F17/D61T

AREAS OF MODIFICATION BETWEEN APPROVED DRAINAGE GRADING PLAN AND ACTUAL AS-BUILT

Jefferson Commons Industrial Park Lot 12

MARCH 1994

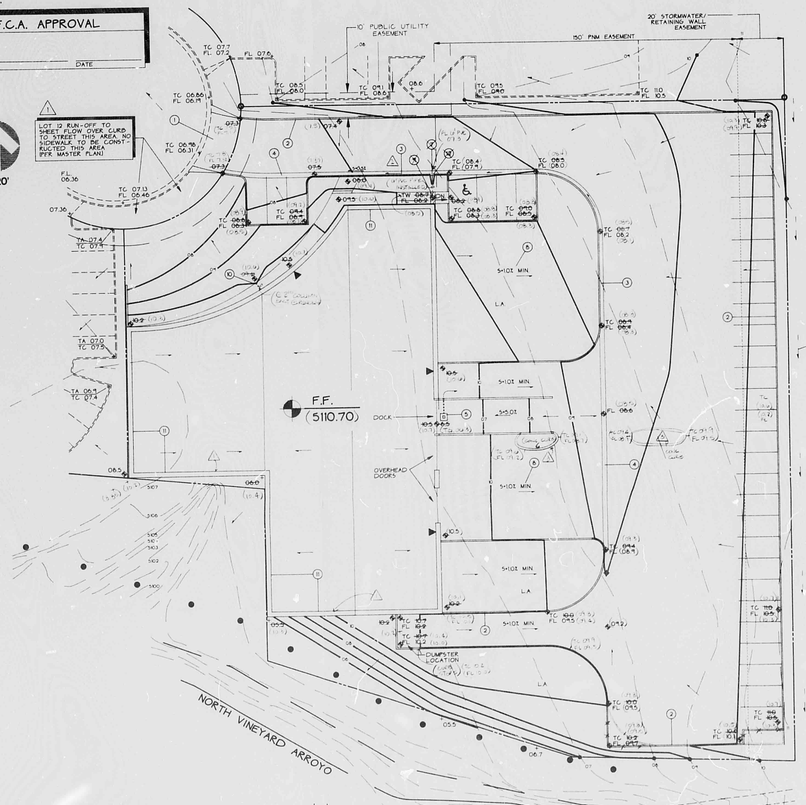
RESUBMITTAL COMMENTS

1 NOTE ADDED AT CUL-DE-SAC

2 GENERAL NOTE ADDED RE: ROOF DOWNSPOUT RUN-OFF

1. Underwalk culvert (see note 9) replaced with 6" pvc pipe. Capacity of 6" pipe is approx. 1.3 cfs, Q = 0.7 cfs OK
2. Additional parking islands constructed.

A. Extended stemwall of building portion adjacent to AMAFCA property not constructed.

GENERAL NOTE AT ALL DOWNSPOUT LOCATIONS LOCATED WITHIN A LANDSCAPED AREA ALL ROOF RUN-OFF SHALL BE DIRECTED TOWARDS AN ASPHALT AREA AT A MINIMUM SLOPE OF 1%
